Works instruction

Adjustable 6 CAM timer

Effective from : 25/08/2011
 Machine(s) effected : Hood Machines
 Revision : B

Document :
 WI-PROD-158

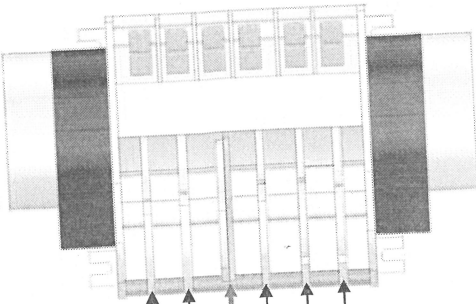
Step	Action	Picture
1	From 25 August 2011 (Week Code 1134) Classeq hood machines will start to use a new cam timer with an adjustable rinse cam.	
2	CAM 4 - NEW adjustable ORANGE section	
3	Make sure that the wires on CAM 4 are changed to match the picture	
4	<p>Use the plastic driver to adjust CAM 4 on the timer as per the following:</p> <p>All Airbreak All H957AS All Water Softeners } Either ensure the gap is 7mm, or use 'Duo 750' adjuster key</p> <p>For All <u>Pressurised Tank</u> versions ensure that the gap is fully open as shown</p>
